WORK TO BE PERFORMED UNDER THIS PROJECT INCLUDES THE CONSTRUCTION OF A NORTHBOUND LEFT TURN LANE, AND INSTALLING A SIGNALIZED TRAFFIC SYSTEM, WITH RELATED PAVEMENT MARKINGS AND SIGNS.

CONTRACTOR: ENGINEERS CONSTRUCTION, INC. - SO. BURLINGTON, VT
RESIDENT ENGINEER: T. POCKETTE
CONSTRUCTION BEGAN: JULY 5, 2005
CONSTRUCTION COMPLETE: NOVEMBER 13, 2005
RECORD PLANS BY: T. POCKETTE & N. GARBACIK

PROJECT NAME : **CLARENDON**
PROJECT NUMBER : **NHG SGNL (24)**

Scan- x61

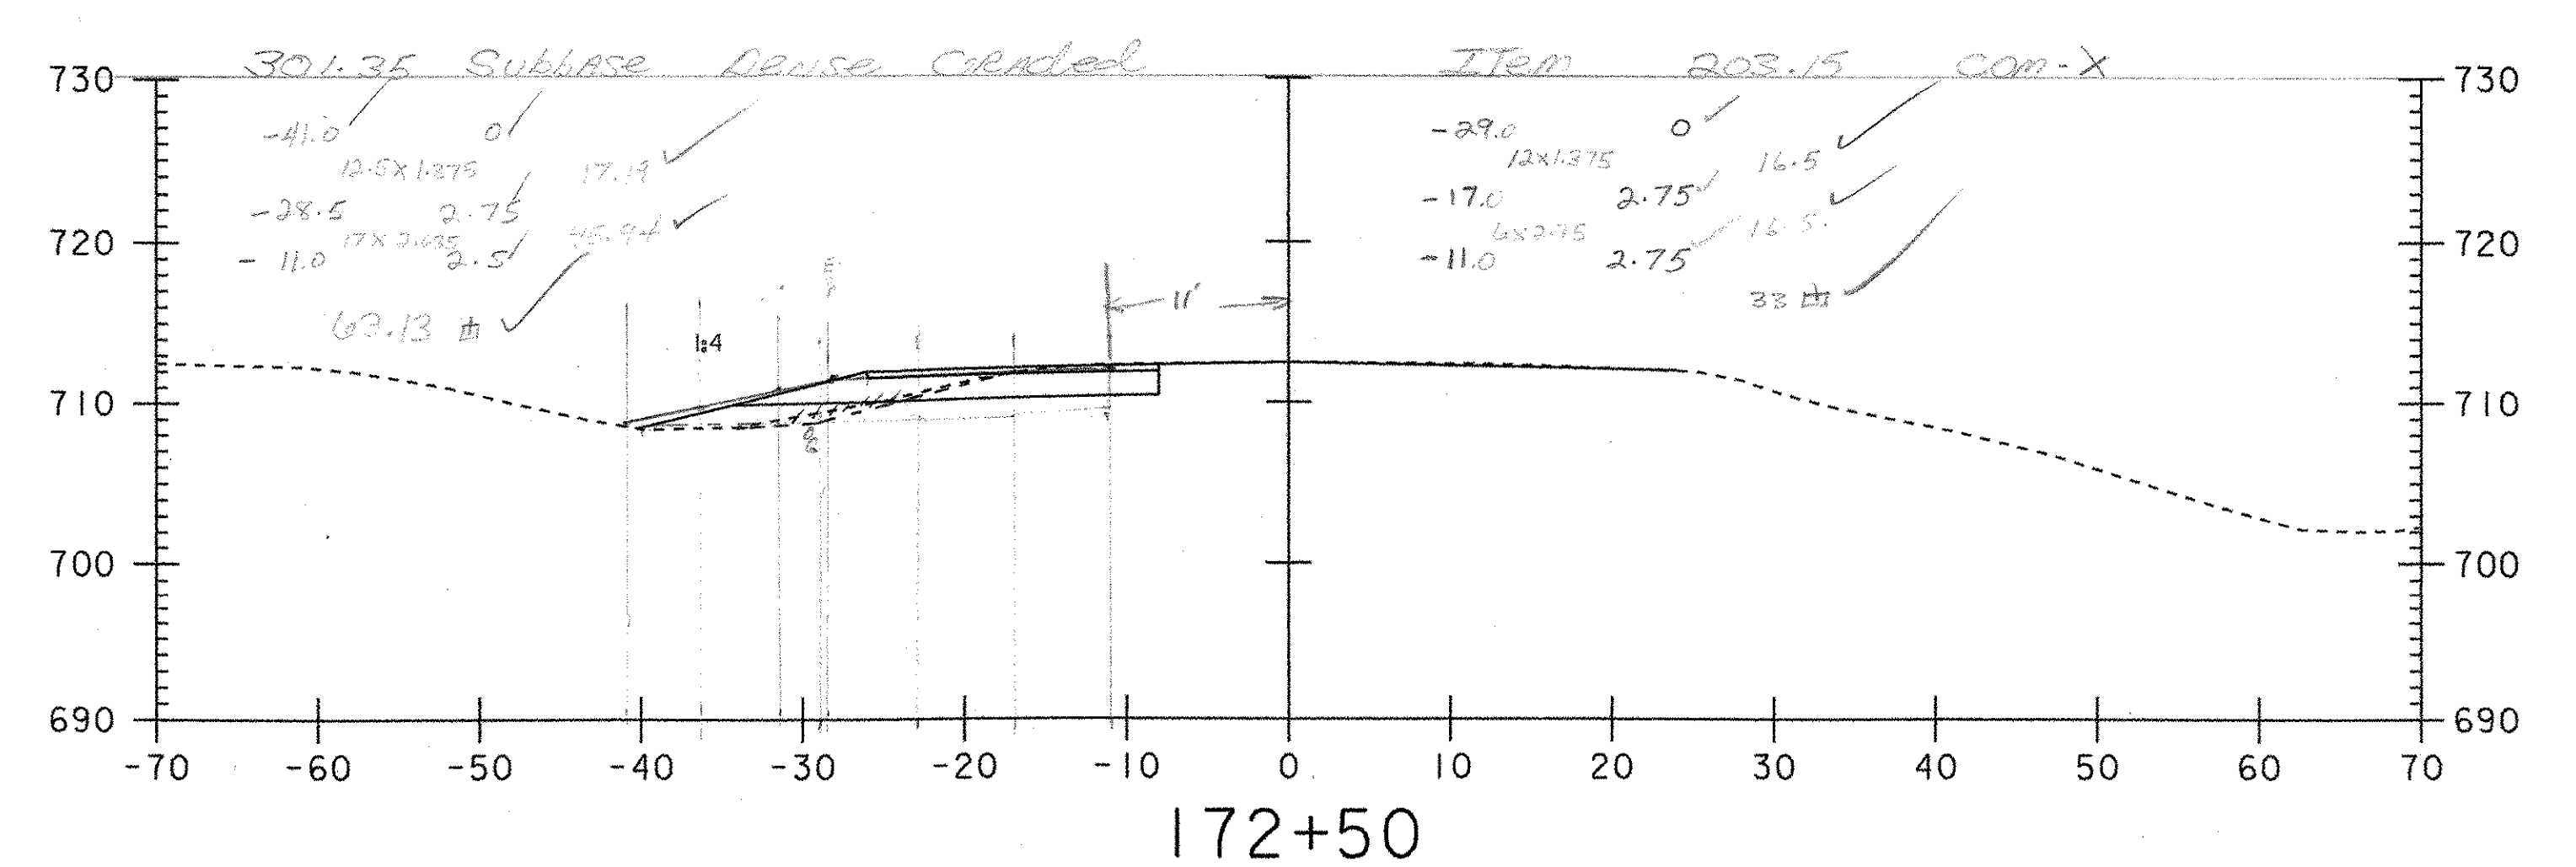
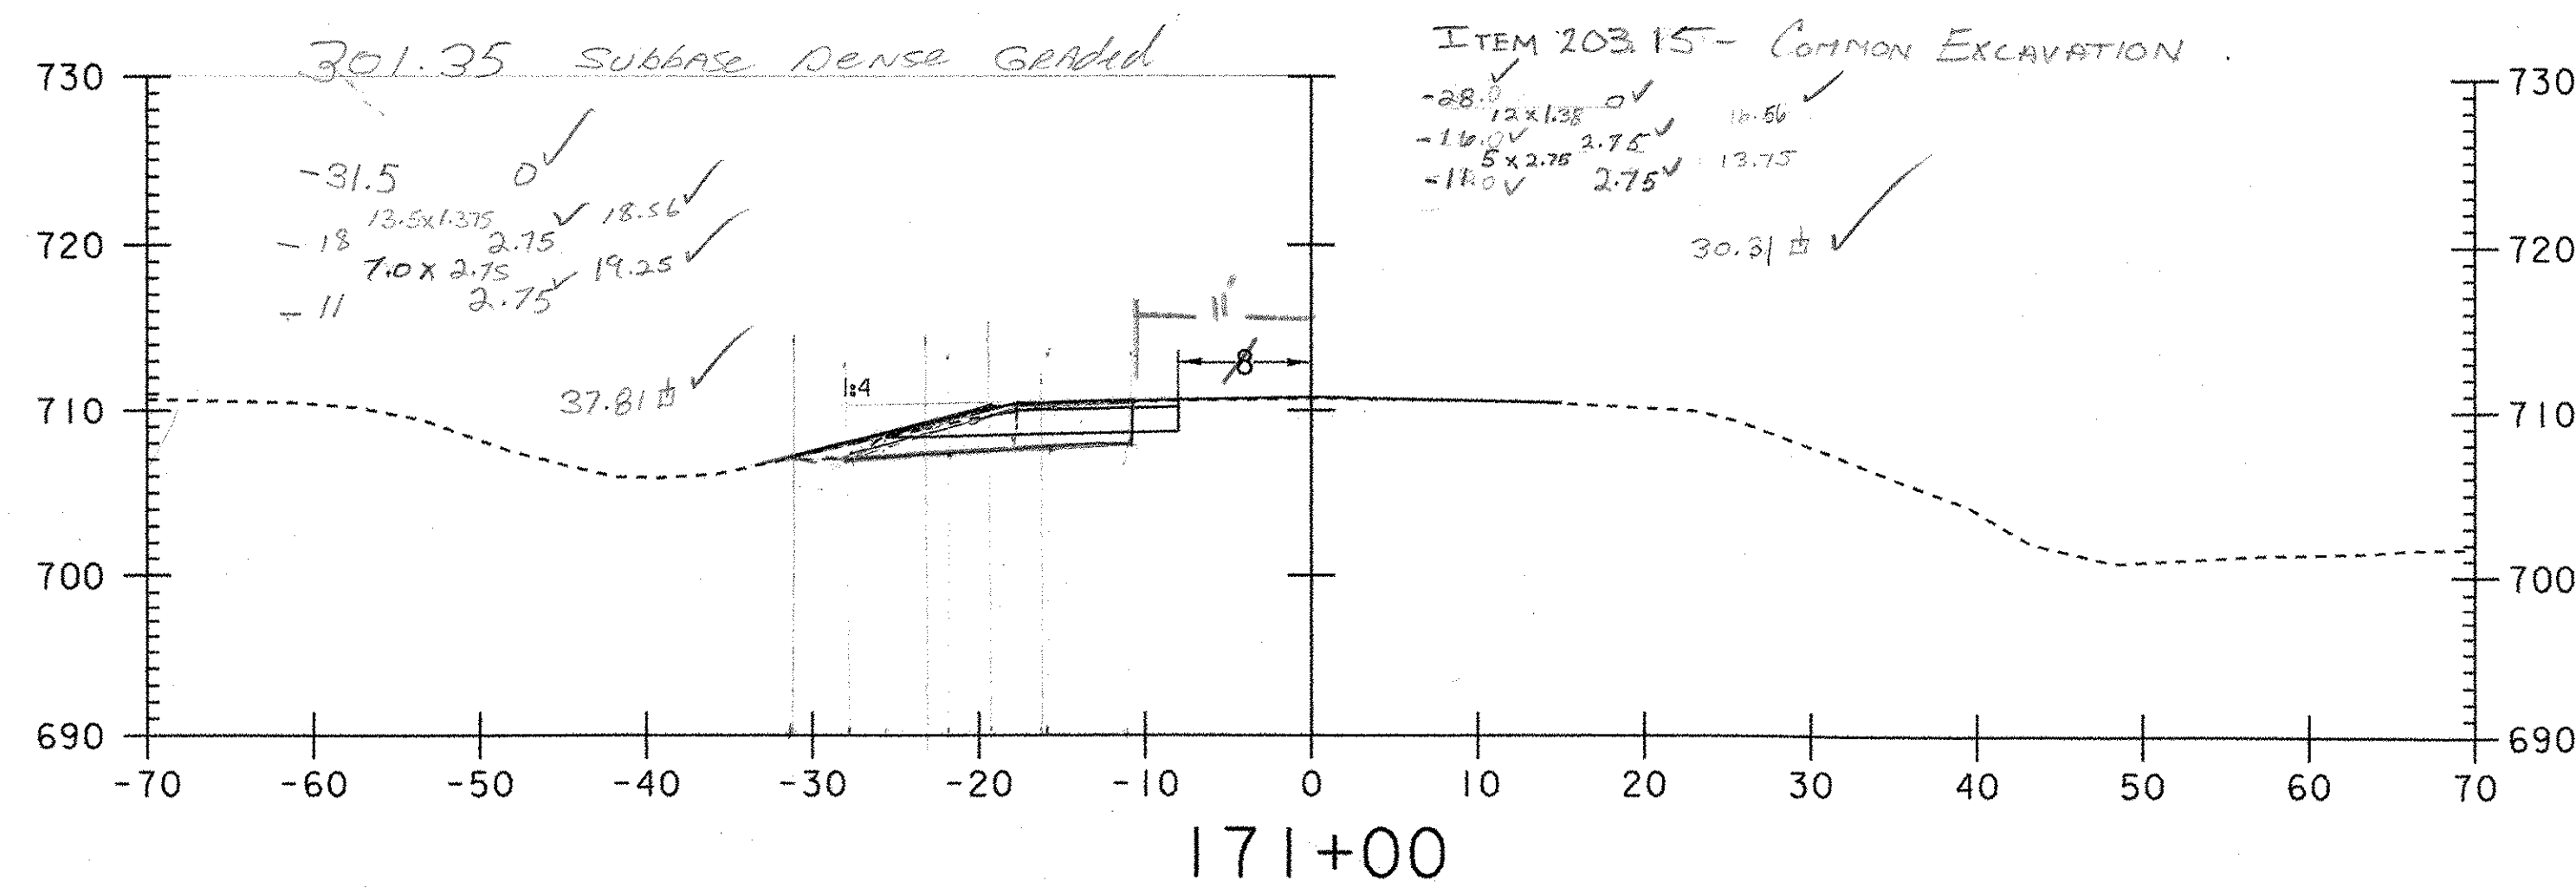
ITEM 203.15 - Common Excavation
 Quantities sent to Spreadsheet for
 final Quantities. See Sheets
 203.15-1 to 203.15-2 for details. (TP)

ITEM 301.35 - Subbase of Dense Graded Crushed Stone
 Quantities sent to Spreadsheet for
 final Quantities. See Sheets
 301.35-1 to 301.35-2 for details. (TP)

ITEM 301.35- SUBBASE OF DENSE GRADED
CRUSHED STONE

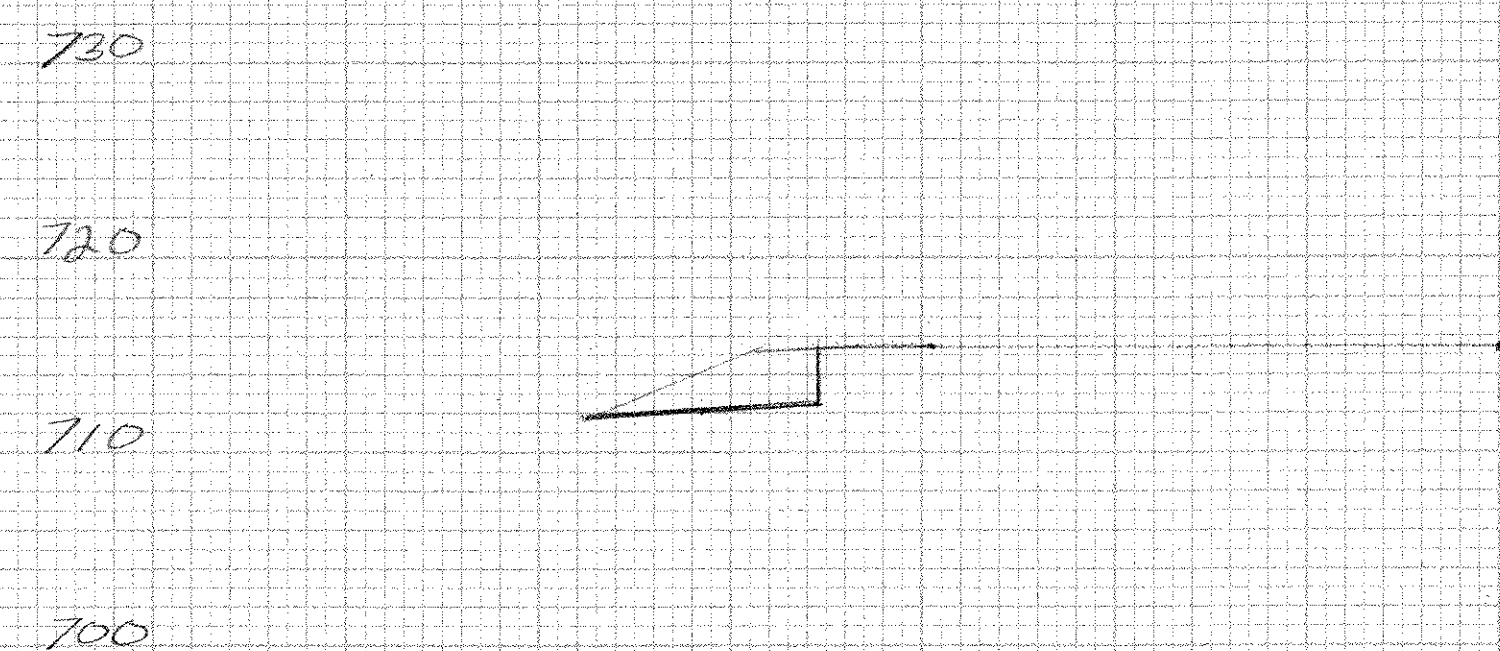
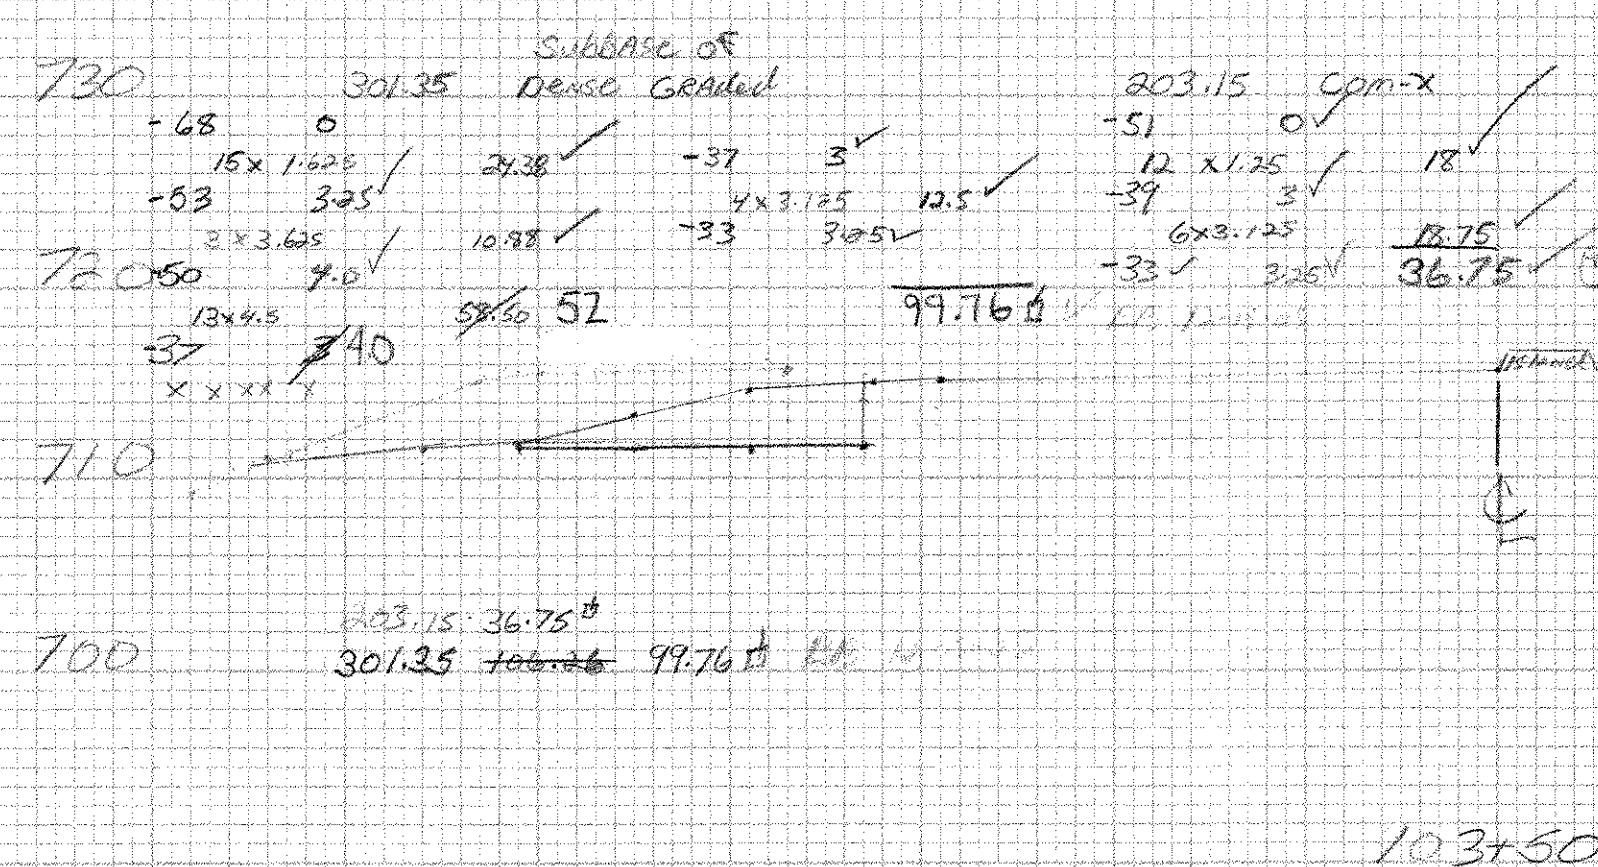
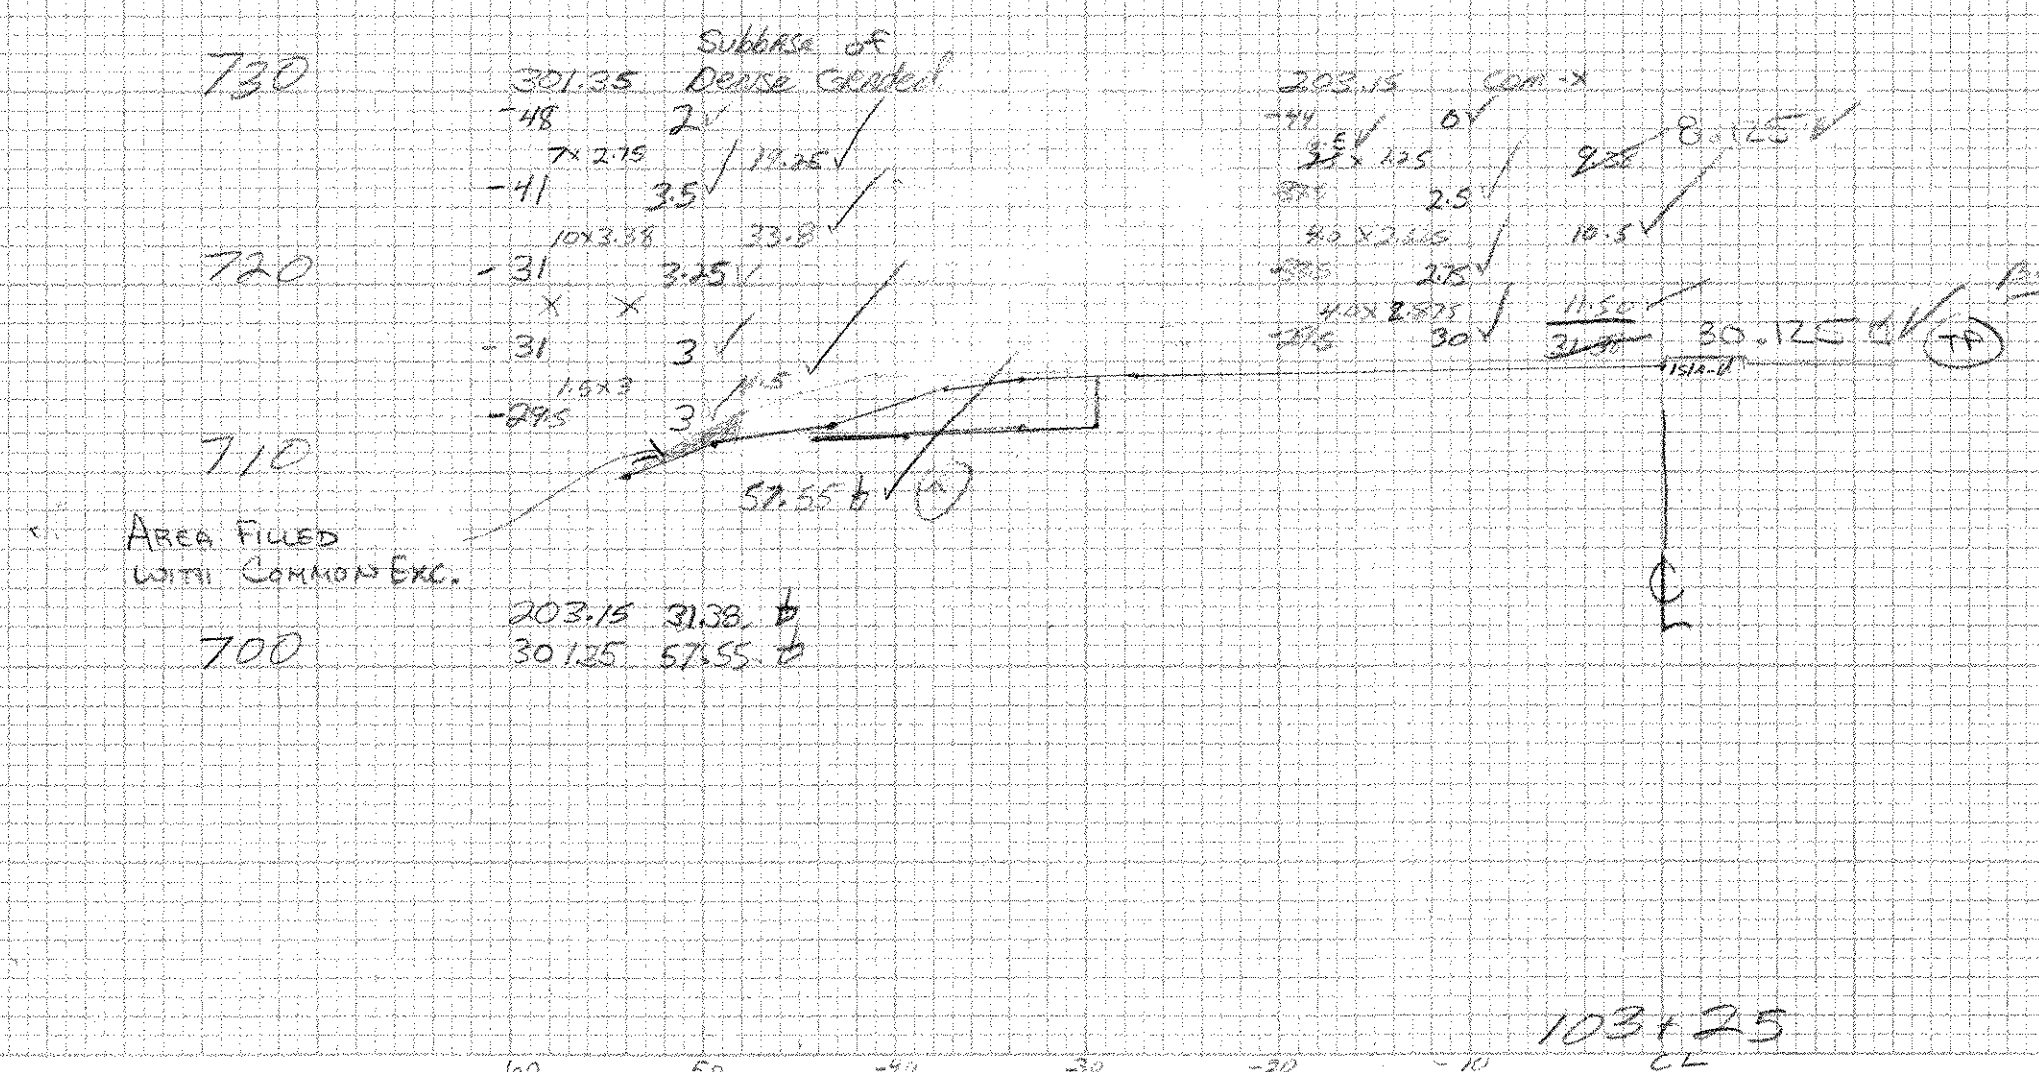
ITEM 203.15 - COMMON EXCAVATION
QUANTITIES TO SPREADSHEET FOR
CALCULATIONS OF FINAL QUANTITIES.
SEE SHEETS 203.15-1 TO 203.15-2
OF CALCULATION BINDER FOR DETAILS (TP)

QUANTITIES TO SPREADSHEET FOR
CALCULATION OF FINAL QUANTITIES
SEE SHEETS 301.35-1 TO 301.35-2
OF CALCULATION BINDER FOR DETAILS
